FORM APPROVED
OMB NO. 1004-0135
Expires: July 31, 2010**SUNDRY NOTICES AND REPORTS ON WELLS**
*Do not use this form for proposals to drill or to re-enter an abandoned well. Use form 3160-3 (APD) for such proposals.*5. Lease Serial No.
NMNM97874

CONOCO "22" FEDERAL COM 001 ✓

30-015-31457 ✓

**Conoco 22 Federal Com 1
30-015-31457
Cimarex Energy Co. of Colorado
February 24, 2011
Conditions of Approval**

PROPOSED
PROPOSED WELLBORE DIAGRAM
Cimarex Energy Company

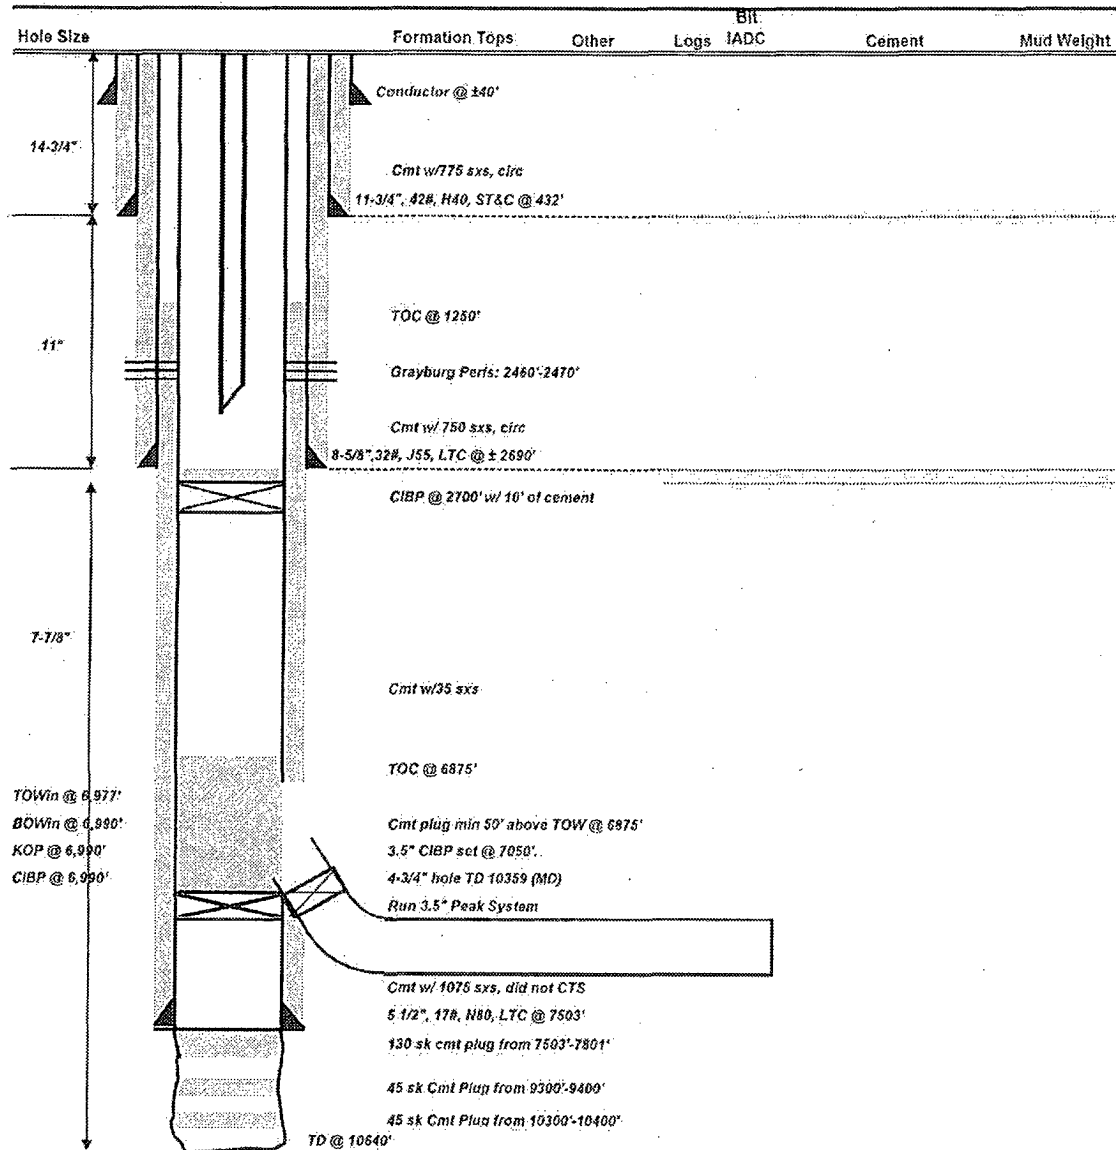
- 1. Contact BLM 575-361-2822 a minimum of 4 hours prior to setting CIBP at 7050 feet. PET to witness placement of CIBP in horizontal leg and pressure test.**

- 5. Operator to place 35' of cement on top of CIBP at 2700'.**
- 6. Submit subsequent report with current wellbore schematic and well test when work is completed.**
